## **Generic Design Assessment – New Civil Reactor Build**

**GDA Close-out for the EDF and AREVA UK EPR™ Reactor**

**GDA Issue GI-UKEPR-FS-04 Revision 0**

**Steam Generator Tube Rupture Safety Case**

Figure 1. Simplified schematic view of the location of the radioactive KRT detectors

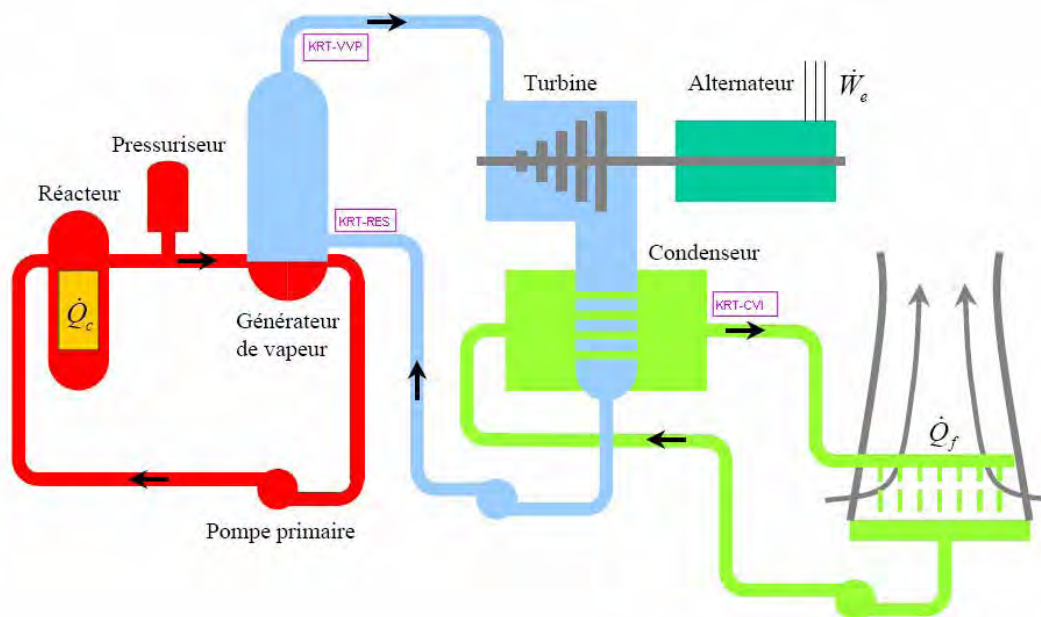
111 In TQ-EPR-1603 (Ref. 13), I requested that EDF and AREVA provide the layout of the proposed component configuration and outline the measures taken to ensure that the redundant detection systems are located in an optimum manner within the space restriction. EDF and AREVA in their response have indicated that a feasibility assessment has been performed with the space constraints on the existing plant design. This feasibility study has shown that the additional sensor could be installed in the main steam line adjacent to the existing sensor. A suitable space envelope has been identified which may require re-positioning of the original sensor to accommodate the proposed second sensor.

- 
- 112 EDF and AREVA also indicated that although the space envelope has been identified, the revised configuration has not been fully integrated into the detailed proposed design plant layout. EDF and AREVA have however performed an impact assessment to demonstrate that the safety role of this equipment can be performed within the space constraint.

**AF-UKEPR-FS-88:** *The licensee shall provide a robust justification that the position of the steam line activity sensors is optimised to maximise their sensitivity for detecting the activity released from SGTR faults or to minimise potential radiological discharge to atmosphere.*
